# ORIGINATION FORM

Proposed Revisions to a Design Standards Index  
(Please provide all information – Incomplete forms will be returned)

Index Number: **17745**  
Sheet Number (s): 1, 2 and 6 of 6  
Index Title: Mast Arm Assemblies

Sheet 1: Added Separate conduit for lighting to the foundation.  
Sheet 2: Change foundation reinforcing lap splice to 2'-0"; Change backing ring to 2".  
Sheet 6: Changed the handhole diameter to 5" in the upper MAST ARM HANDHOLE detail; Clarified Note 2.

FOUNDATION AND BASE PLATE DETAILS

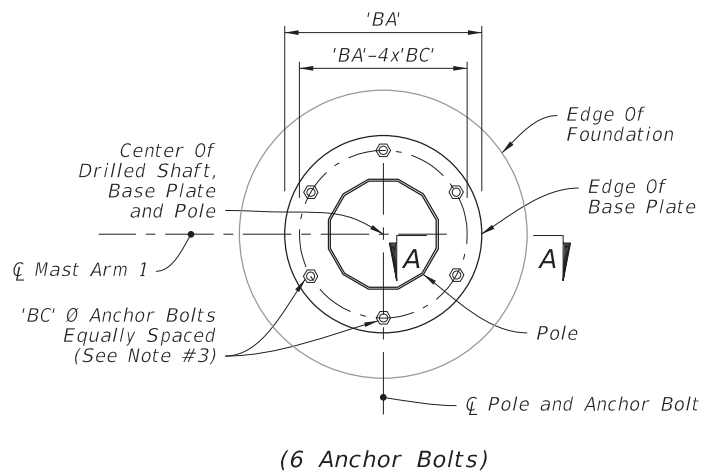
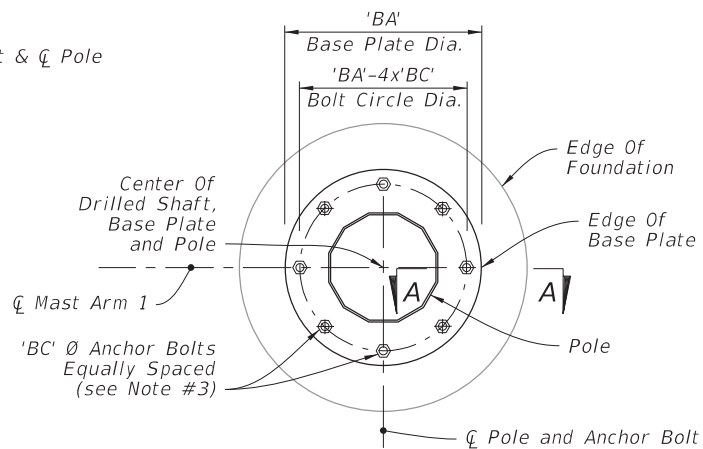
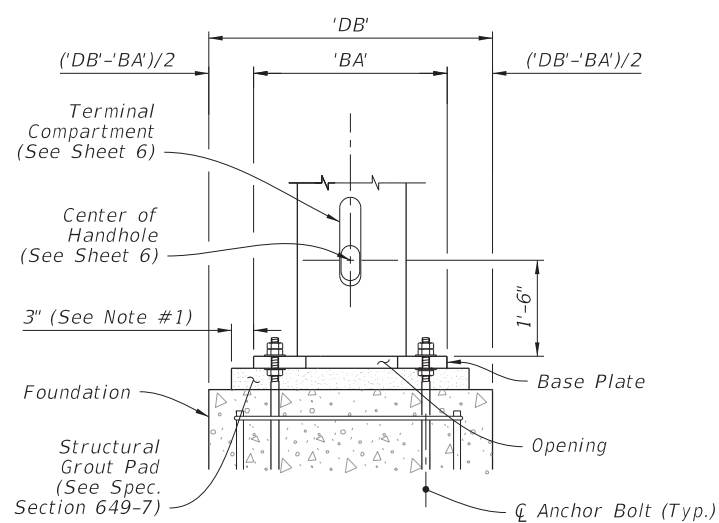
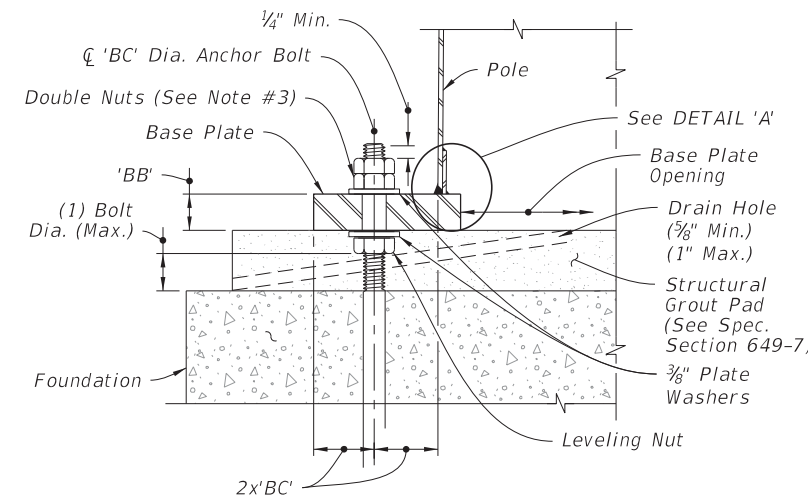
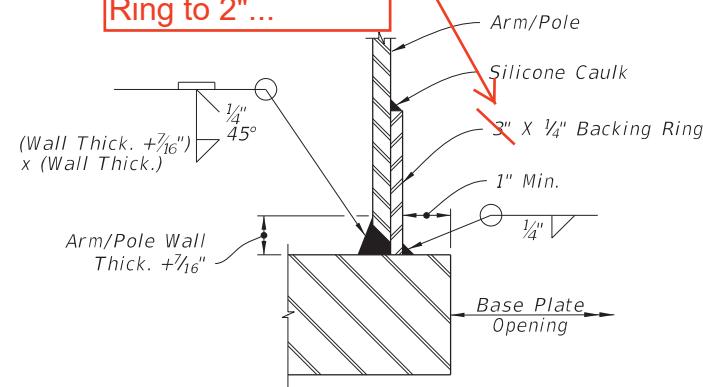
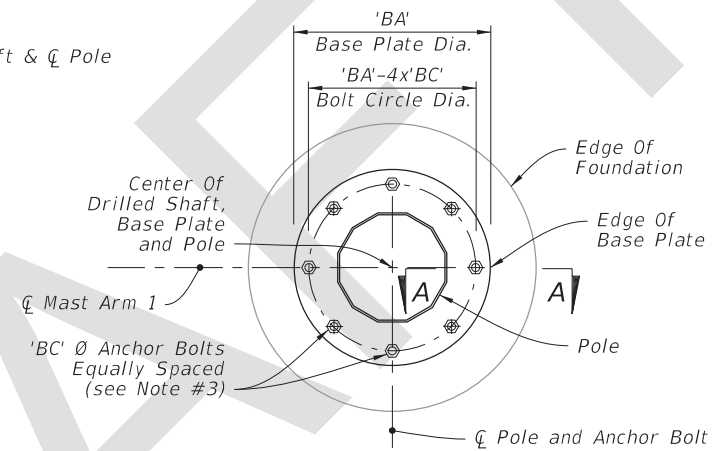
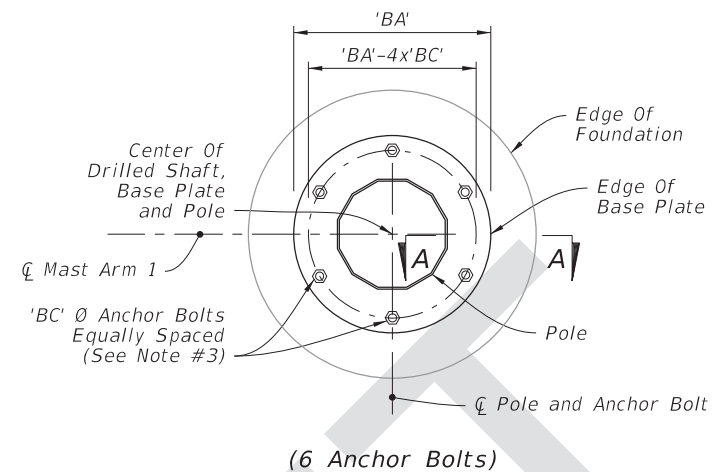
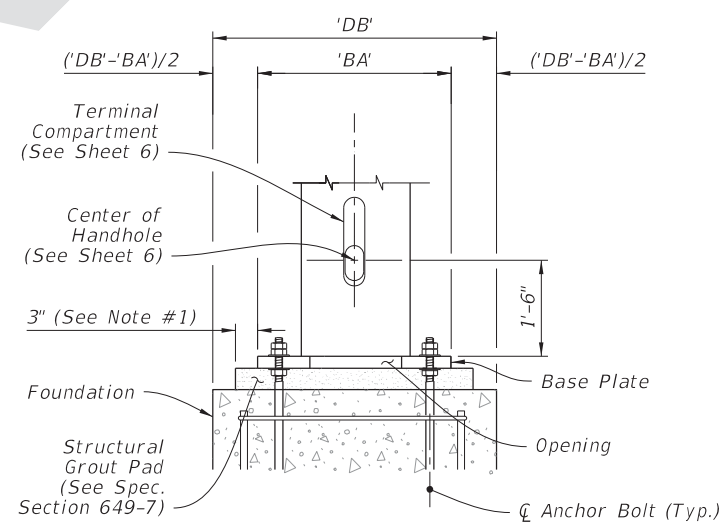
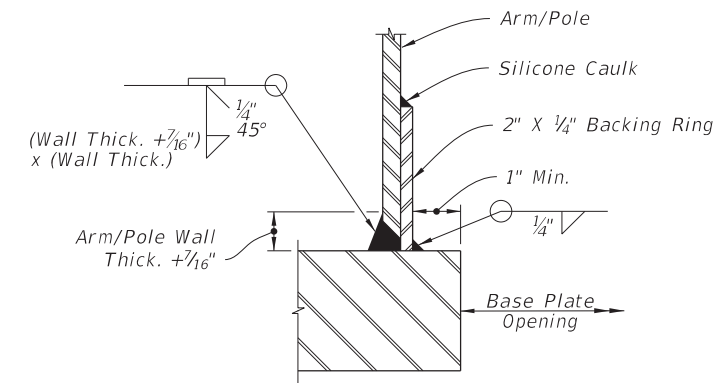
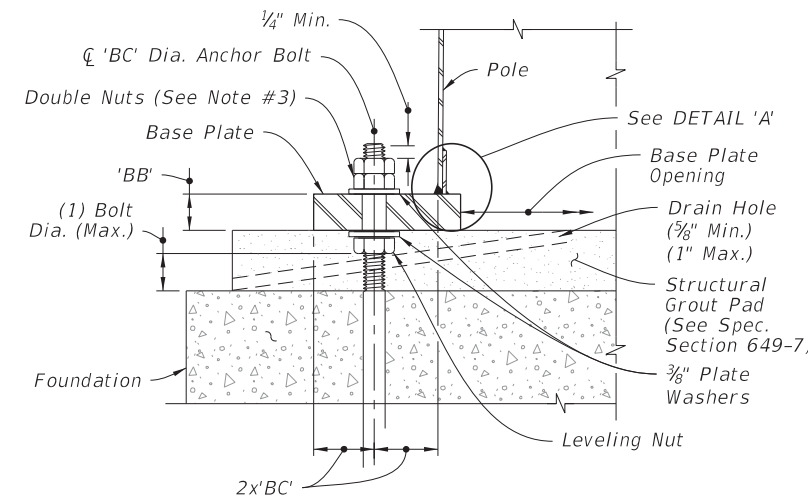
Sheet 2: Standard reinforcing lap splice is 2'-0". Standard backing ring is 2". This is to bring 17745 in line with other standards.  
Sheet 6: This clarification was needed to eliminate possible interpretations that a Terminal Compartment is optional to the Contractor regardless of the plan content. This issue is being further coordinated with industry and the CADD Office to provide a consistent location for this information on the Mast Arm Tabulation Sheet for next cycle.

Changed Backing Ring to 2"...

**NOTES:**

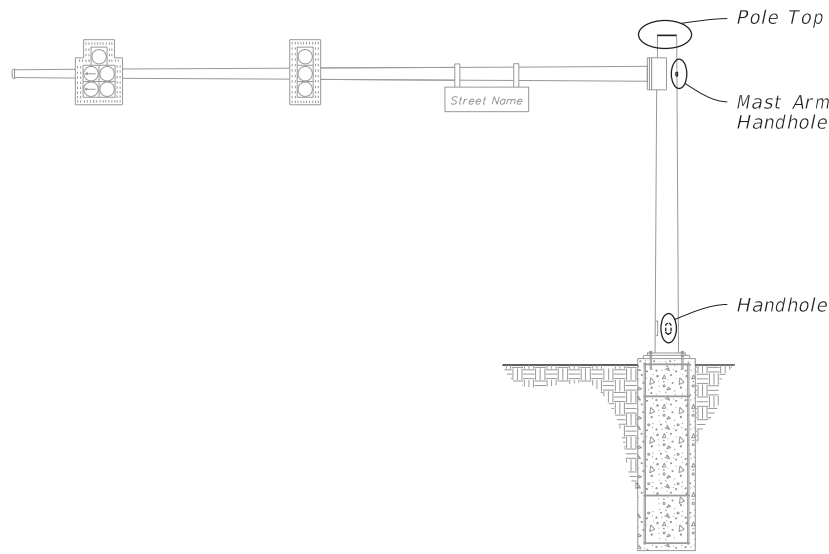
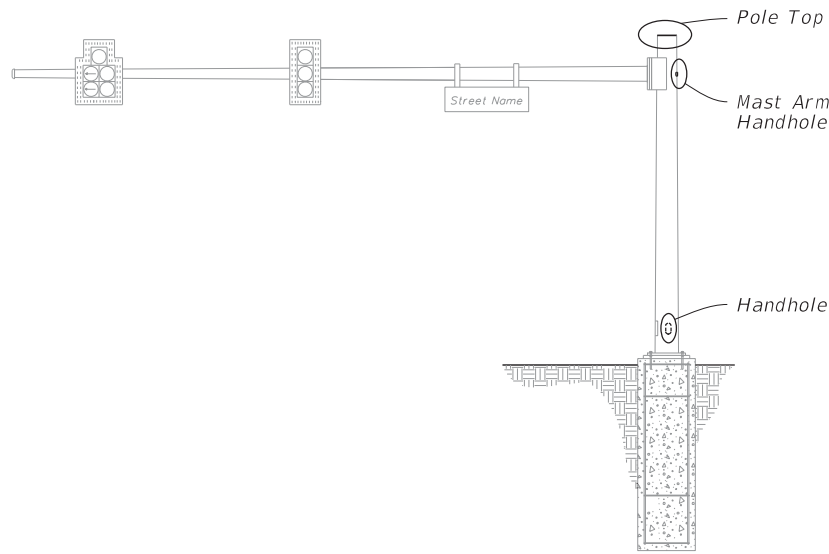
Clarified Note 2

1. Handhole covers may be omitted when Terminal Compartment is provided.
2. See Mast Arm Tabulation sheet to see if Terminal Compartment is required and for locations.
3. Terminal Compartment Frame Height 2'-0" minimum to 2'-6" maximum. Align bottom of Terminal Compartment a minimum of 1" below the bottom of the Handhole Frame.
4. Any combination of Option 'a' or 'b' may be used, provided both lifting and wiring is accommodated.
